Modification Recommended Service Note

Supersedes: DSOS204A-02C

DSOS204A - DSO Infiniium S Series 2GHz 4 channel

The Problem - Under certain circumstances a PLL2 error may occur on the S-series products.

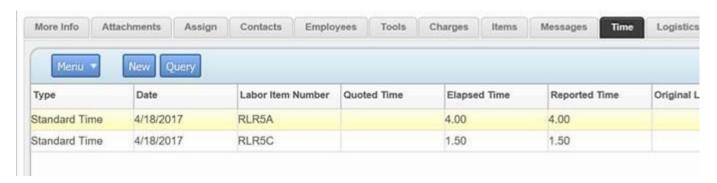
On older acquisition boards a PLL2 error message sometimes occurs. The error message appears on the screen as below:

There are new acquisition boards that fix this issue for the S-series scopes.

Please, use the 54911-69511 board until is gone. If you have a 54911-69511, then skip steps 1 and 2 and proceed to step 3. If there are no 54911-69511, then start with step 1 below.

- 1. If the customer needs to have software revision < 6.10.01001, then replace the acquisition board with the 54911-69532 board.
- 2. If the customer can have software revision >= 6.10.01001, then it can be replaced by any of these three boards: 54911-69521, 54911-69531, or 54911-69532.
